Urgent Field Safety Notice
Product Correction
Immediate Action Required

Date Issued December 8, 2017

Product Name	List Number	UDI
ARCHITECT c4000 Cuvette Segment	02P75-01	Not applicable
ARCHITECT c8000 Cuvette Segment	01G46-01	Not applicable
ARCHITECT c16000 Cuvette Segment	09D32-05	Not applicable

c4000 cuvette segment

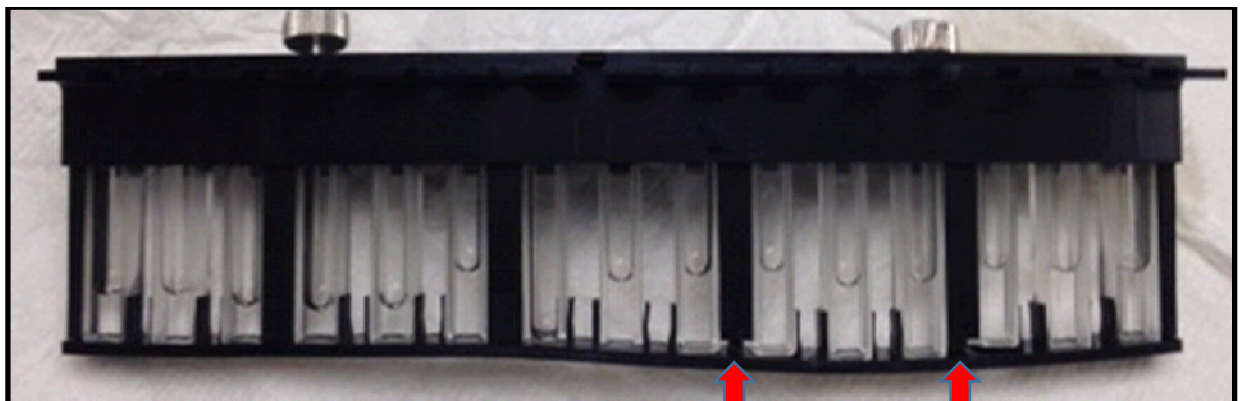
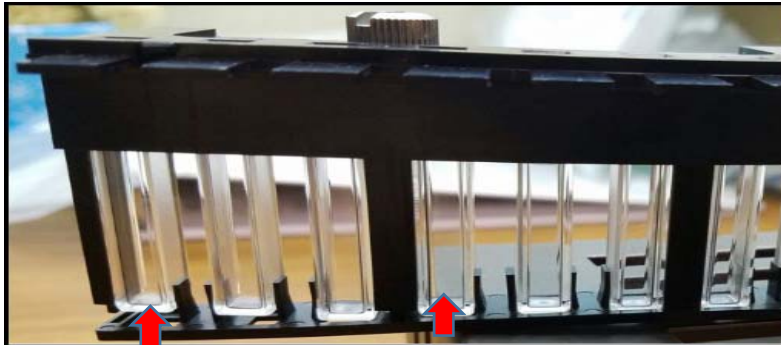
The following pictures show examples of normal, undamaged cuvette segments:
